ENERGY COMPLETE MONOGRAPH

**2021 PUBLIC INPUT TO THE 2021 IECC, IRC CH. 11 AND
ICCPC CH.15**

Publication Date: November 2021

FIGURE C301.1 CLIMATE ZONES

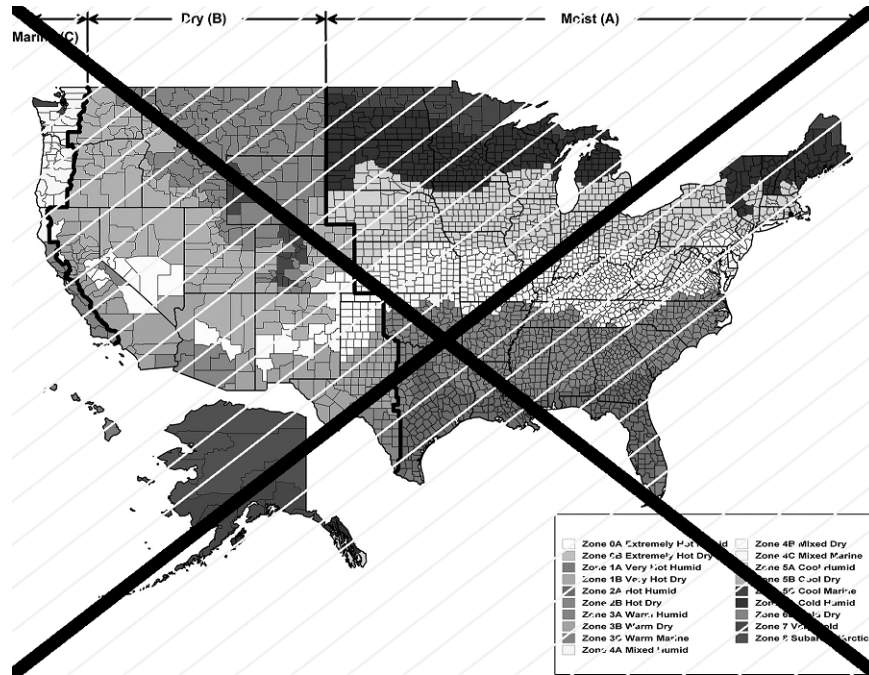
Climate zones shall be as specified in R301. ~~from Figure G301.1 or Table C301.1 shall be used for determining the applicable requirements from Chapter 4. Locations not indicated in Table C301.1 shall be assigned a *climate zone* in accordance with Section G301.3.~~

Delete without substitution:

FIGURE C405.2.4.2(2) DAYLIGHT ZONE UNDER A ROOFTOP MONITOR

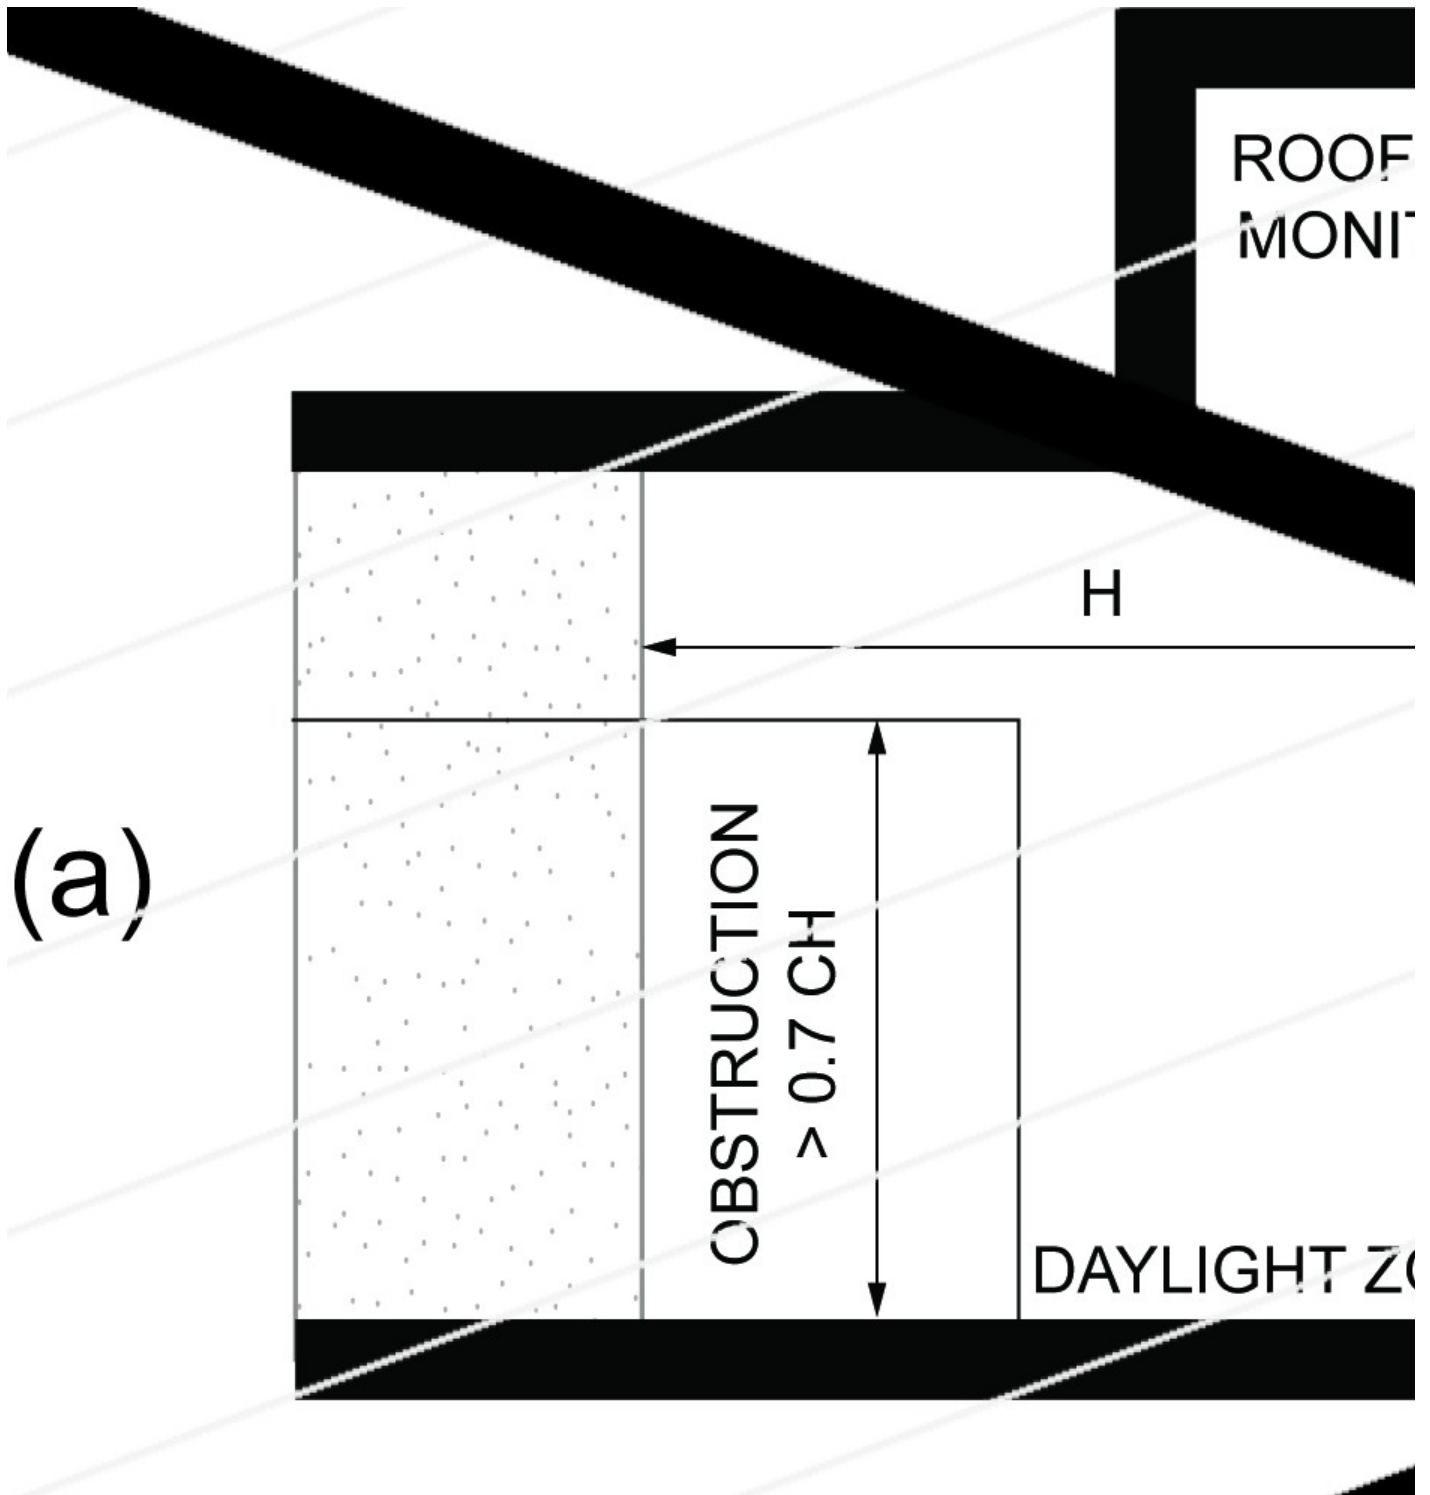
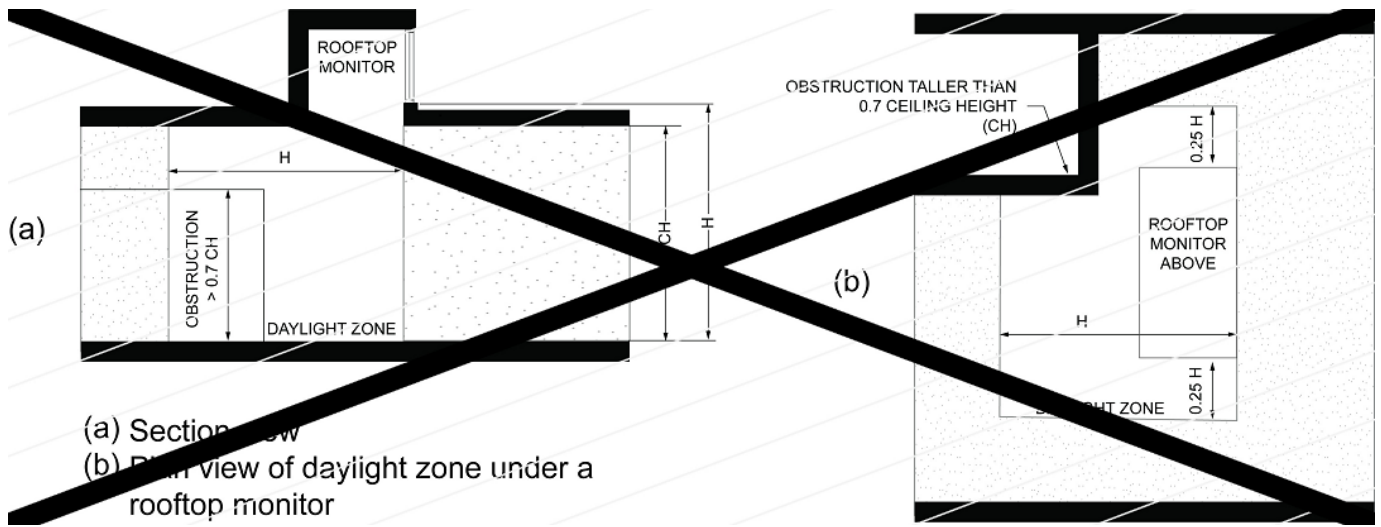
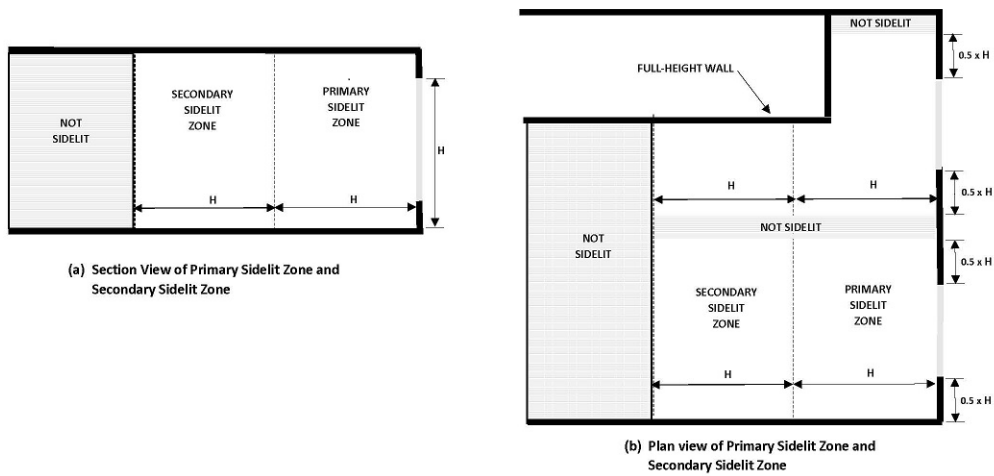
Delete and substitute as follows:

Figure C405.2.4.2(1) is incorrect. The definition for a sidelit daylight zone is to extend longitudinally from the edge of the fenestration up to 0.5 times the height from the floor to the top of the fenestration. Figures attached show in red outline where the figure needs correction in order to match the definition of a sidelit daylight zone in C405.2.4.2.
